Access Compliance Report

Public Rights-of-Way

Intersection ID: 45137	Main Street: LITTLE_WHITEOAK_RD	Cross Street: CATTAIL_CT	Location: NE
ADA ID: 713DE446F2CD	Ramp Type: PerpDiag	Initial Pass/Fail: Fail	Overall Compliance: No
Severity Score: 21.25			
Codes/Mitigation Info/Possible Solution		Field Measurements/Component Compliance

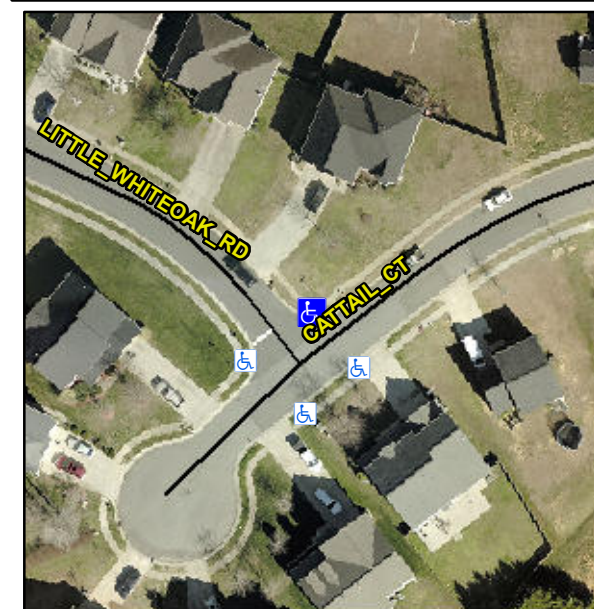
Not Found, R304.5.1, R304.5.3

Compliance	Description	Data	Compliance	Description	Data
N/A	Ramp Length (in)	48.0	Yes	Ramp Slope (%)	7.5
No	Ramp Width (in)	47.5	No	Ramp XSlope (%)	6.0
N/A	Flare Type LT	N/A	N/A	Flare Type RT	N/A
N/A	Flare Slope LT (%)	N/A	N/A	Flare Slope RT (%)	N/A
N/A	Flare Traversable LT?	N/A	N/A	Flare Traversable RT?	N/A
N/A	Landing Length (in)	N/A	N/A	DWS Provided?	N/A
N/A	Landing Width (in)	N/A	N/A	DWS Contrast?	N/A
N/A	Landing Slope (%)	N/A	N/A	DWS Length (in)	N/A
N/A	Landing X Slope (%)	N/A	N/A	DWS Full Width?	N/A
N/A	Landing Curb? (Y/N)	N/A	N/A	DWS Offset (in)	N/A
N/A	Shared Landing?	N/A			
N/A	Gutter Ponding?	N/A	N/A	Gutter Slope (%)	N/A
N/A	Gutter Lip Ht (in)	0.5	N/A	Gutter X Slope (%)	N/A
N/A	Painted X Walk1?	No	N/A	Painted X Walk2?	No
	X Walk 1 Direction	To SW		X Walk 2 Direction	To SE
N/A	X Walk 1 Width (in)	N/A	N/A	X Walk 2 Width (in)	N/A
	X Walk 1 Slope (%)	3.5		X Walk 2 Slope (%)	2.1
	X Walk 1 X Slope (%)	1.9		X Walk 2 X Slope (%)	4.4

Remove & Replace Curb Ramp With Two New Directional Ramps or Equivalent.
